**SAN ANTONIO WATER SYSTEM  
WEST VIEW TANK REPLACEMENT  
SAWS Job No. 15-6102  
Solicitation No. CO-00047**

**ADDENDUM NO. 3  
March 17, 2016**

**Consulting Engineer: River City Engineering, PLLC  
TBPE Registration No. F-1546**

SHEET NO. C-04

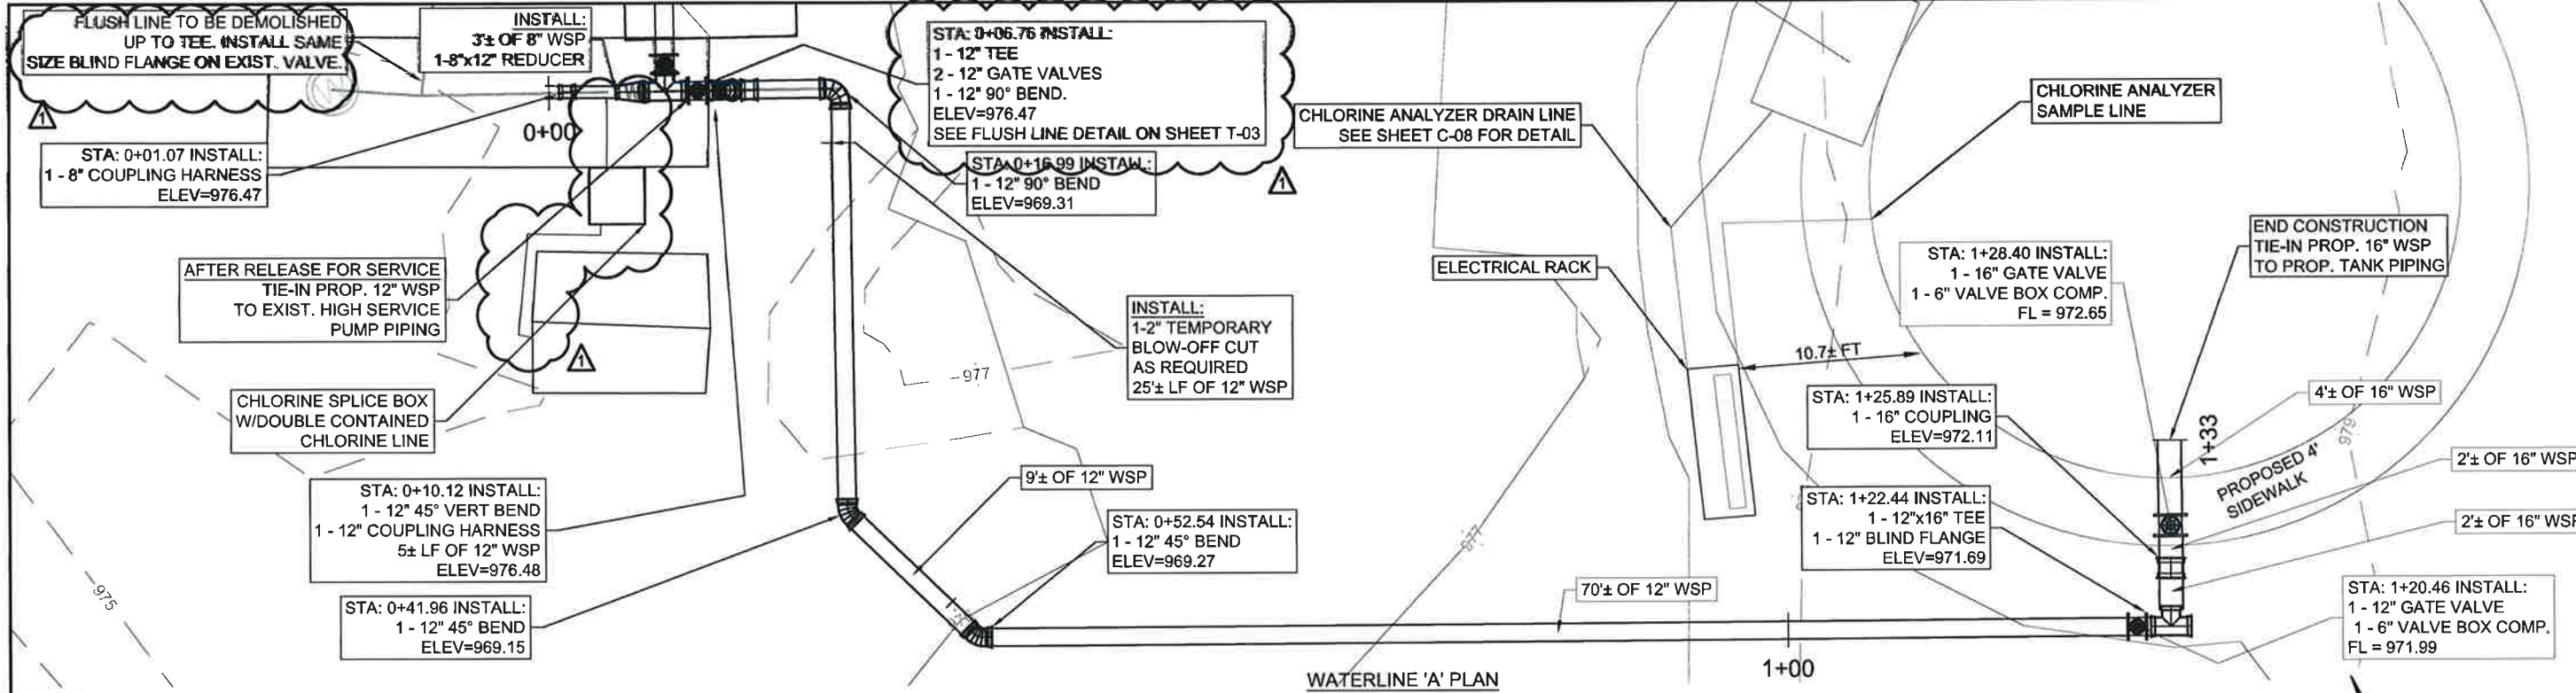
18. Question: The site improvements Plan, Sheet C-04 shows the existing gravel road running thru the proposed Ground Storage Tank. Please clarify where the gravel will terminate. Due to the heavy equipment that will be required during construction we would like to respectfully suggest adding 6" limestone base to the existing gravel road at the construction of the project.

Response: The termination of the existing gravel road as well as the addition of limestone base to the existing gravel road at the conclusion of the project has been addressed in a modification of attached Sheet C-04 of this Addendum.

SAN ANTONIO WATER SYSTEM  
WEST VIEW TANK REPLACEMENT  
WATERLINE B  
SHEET NO. C-07  
12 OF 30 SHEETS

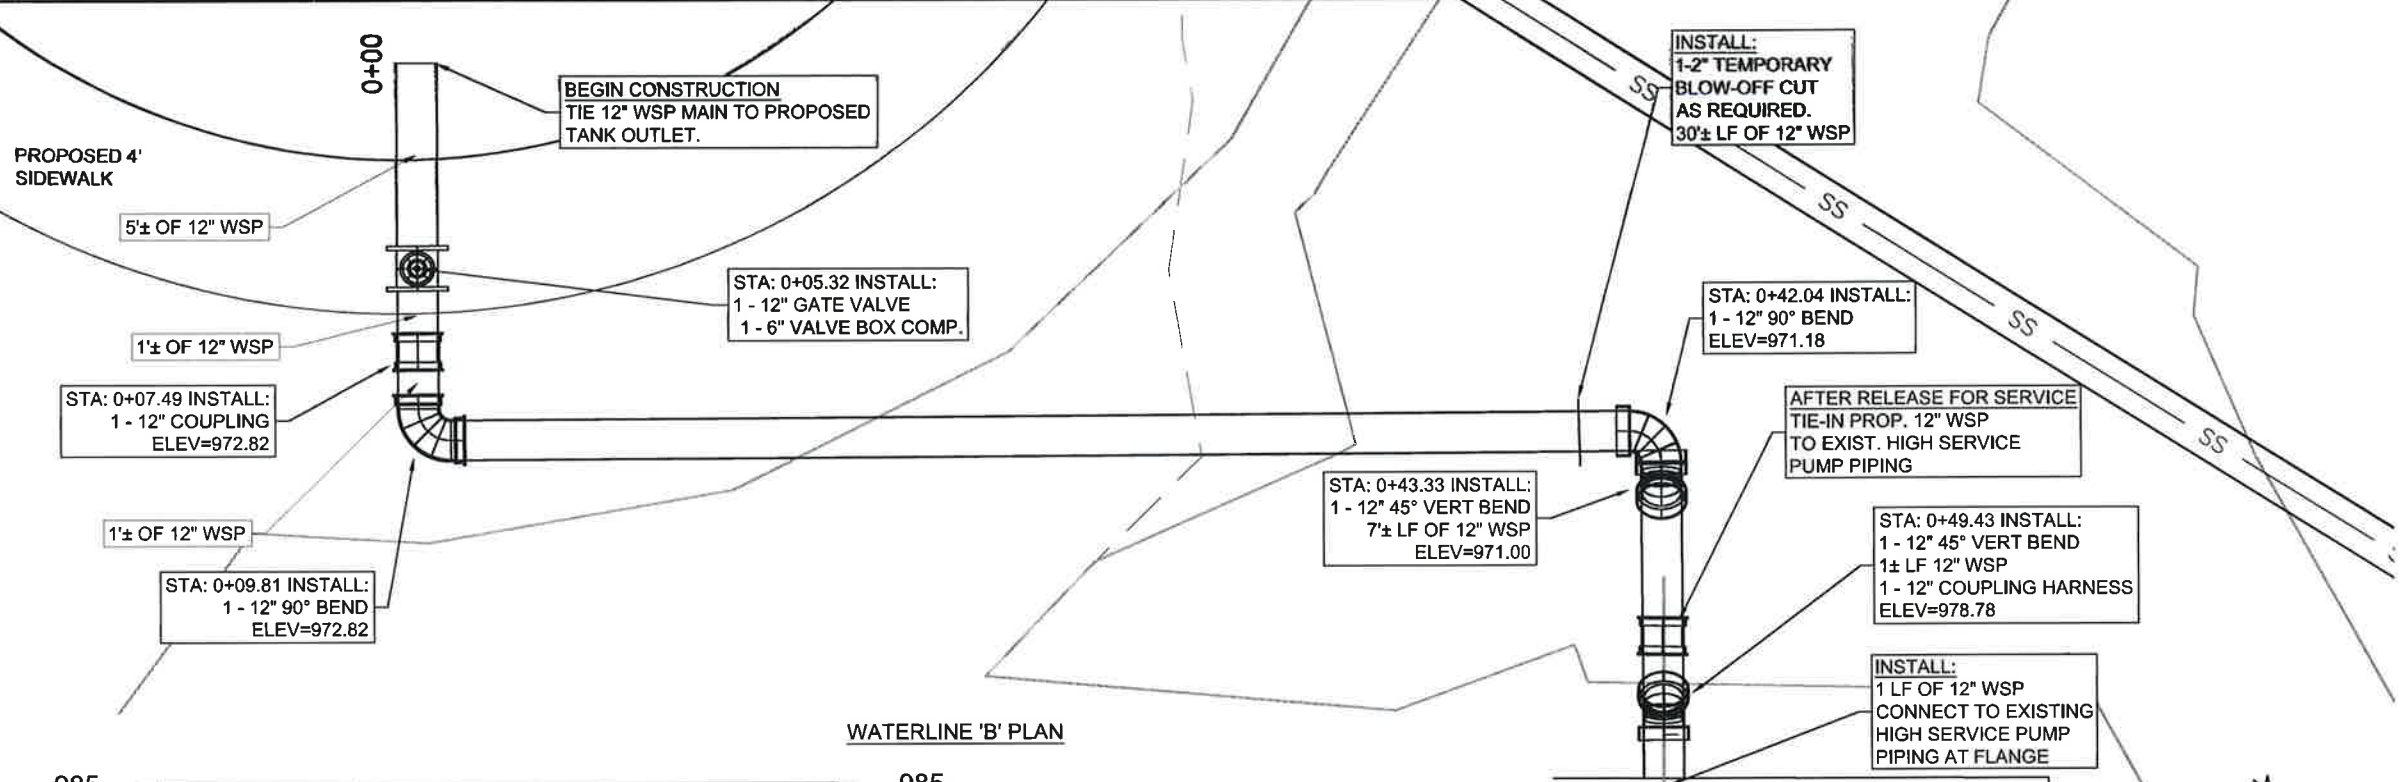
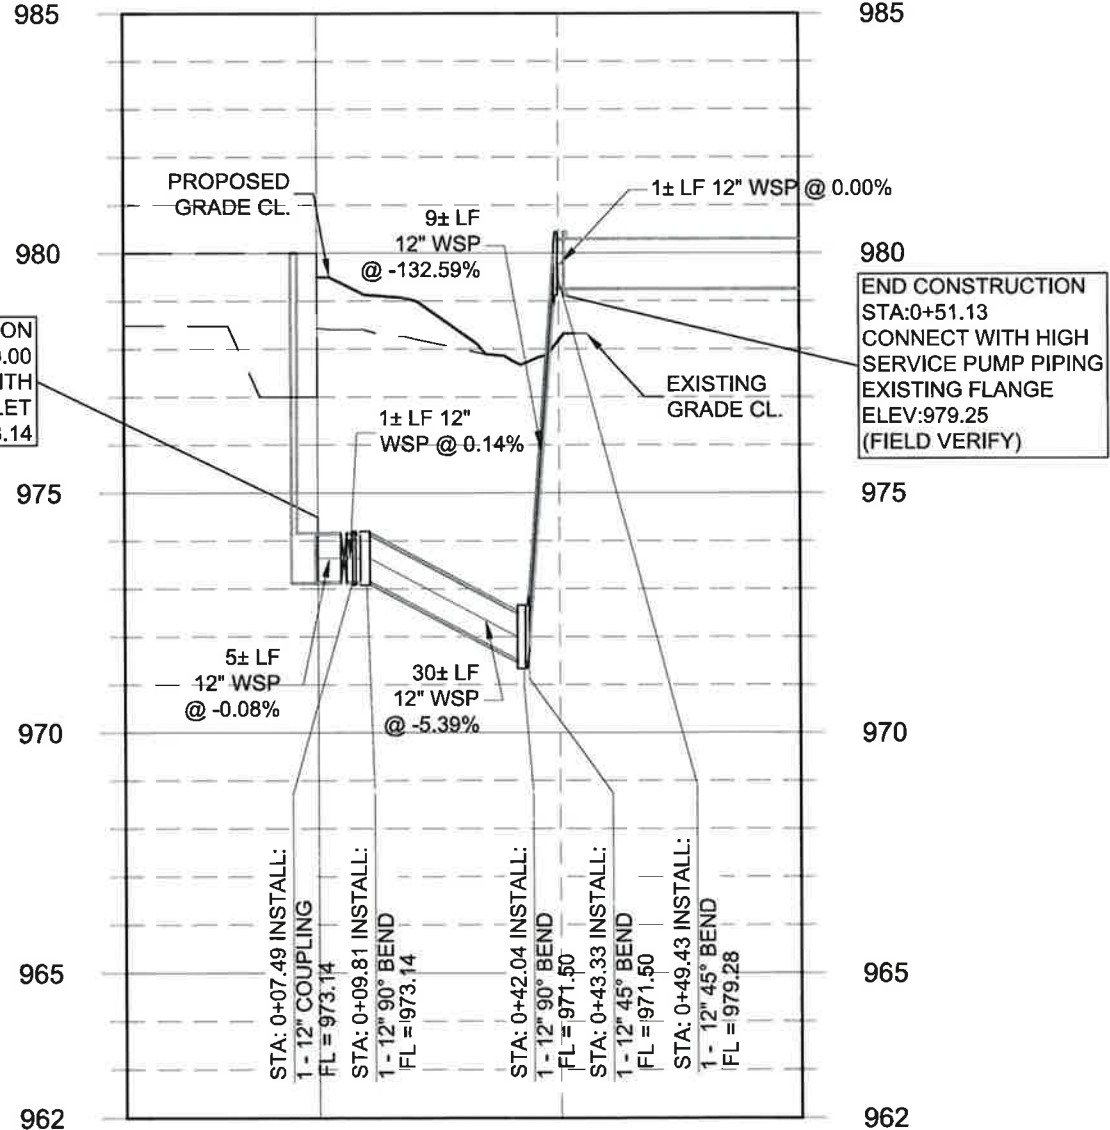
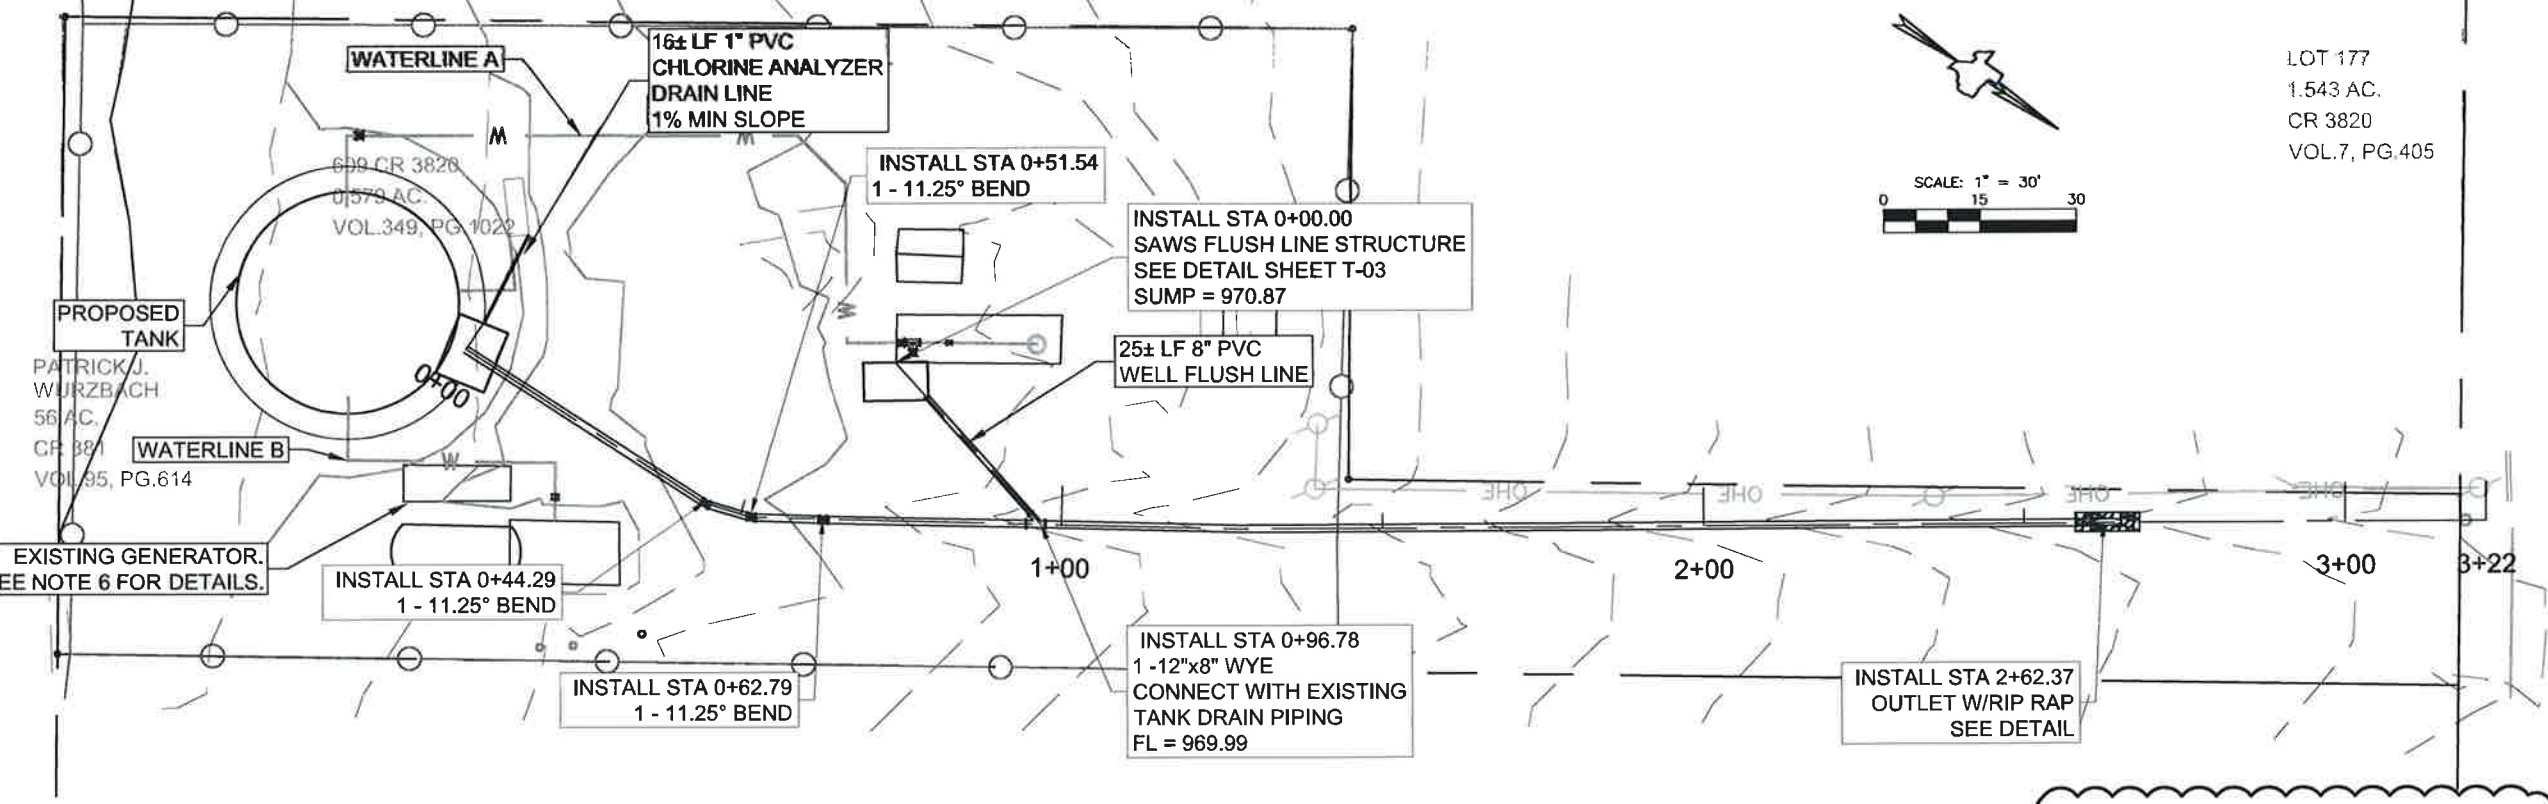
11. Question: Plan Sheet C-07 indicates a 12" tank outlet. Detail 2 on Sheet T-02 indicates a 16" tank outlet. Please clarify.

20. Question: The Plan Sheets C-04 & C-07 indicate the outlet piping as wholly 12" in diameter. The Detail Sheet T-02 indicates the outlet piping initially as 16" in diameter. What size is the tank's outlet piping connection?

Response: The use of Ductile Iron pipe or PVC pipe is not acceptable: The contract documents have been modified within this Addendum to allow other means of restraining, flanged joints and/or restrained harnessed mechanical couplings, the buried steel pipe. Please reference Item Nos. 44, 50 and 51 in the Specifications and Drawings Sections below and attached Sheets C-06 and C-07 for modifications.

Response: The tank outlet is now shown as 12 inches. Please reference Item No. 56 in the Drawings Section below and attached Sheet T-02 for modifications.

SHEET NO. **C-09**  
14 of 30 SHEETS

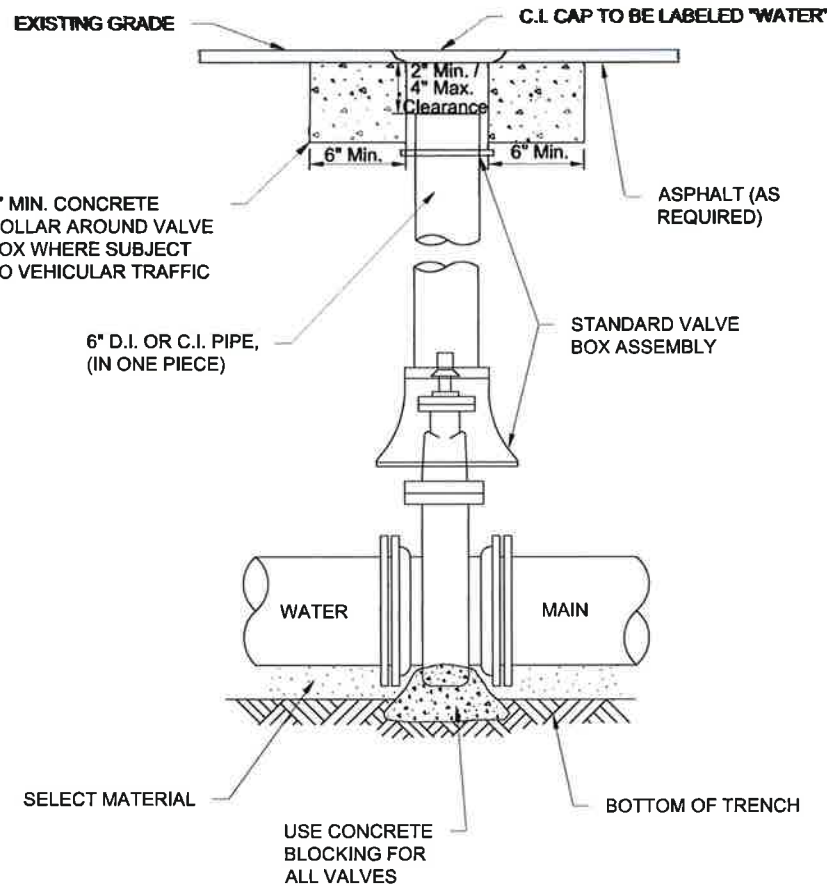
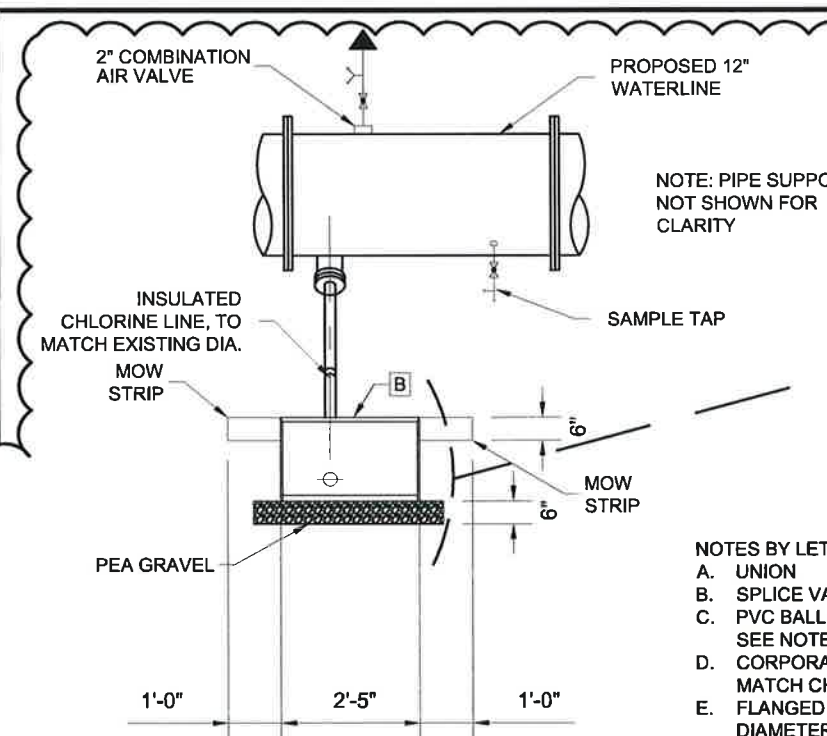
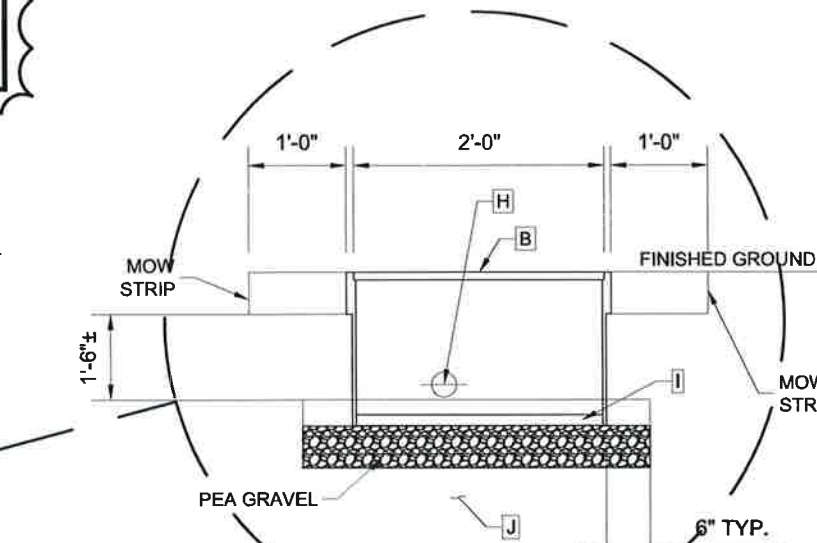
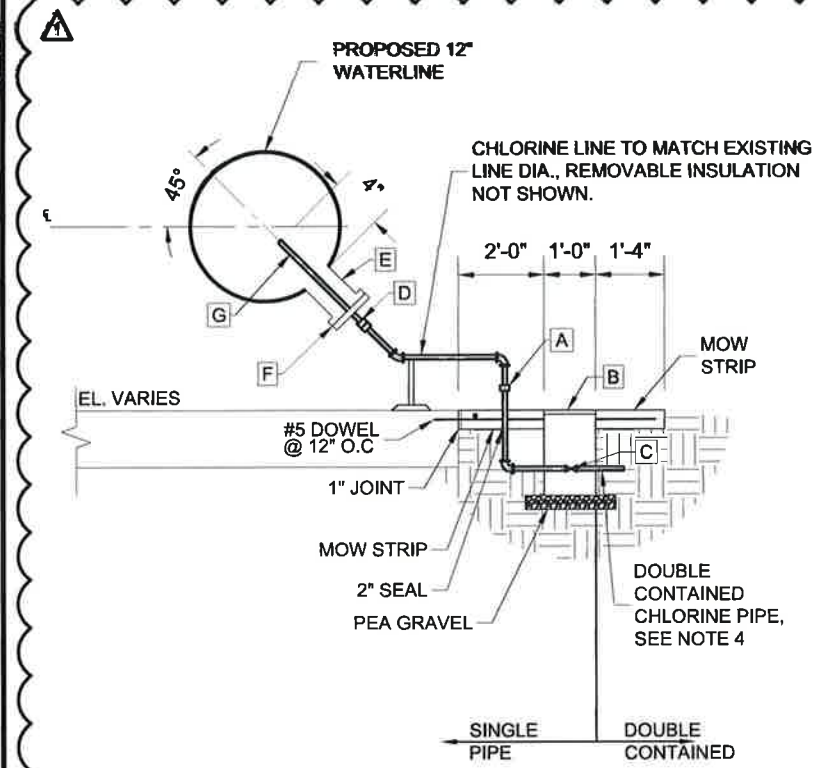
21. Question: Detail 3 on Sheet C-09 calls for field applied liquid epoxy lining. Since the pipe is only 12" this will require a hand hole at each joint. Can hand holes be installed on the pipe or will butt straps with hand holes be required?

Response: Details 3 and 4 have been deleted from Sheet C-09. The contract documents has been modified to allow other means of restraining, flanged joints and/or restrained harnessed mechanical couplings, the buried steel pipe. Please reference Item Nos. 44 and 53 in the Specifications and Drawings Sections below and attached Sheet C-09 for modifications.
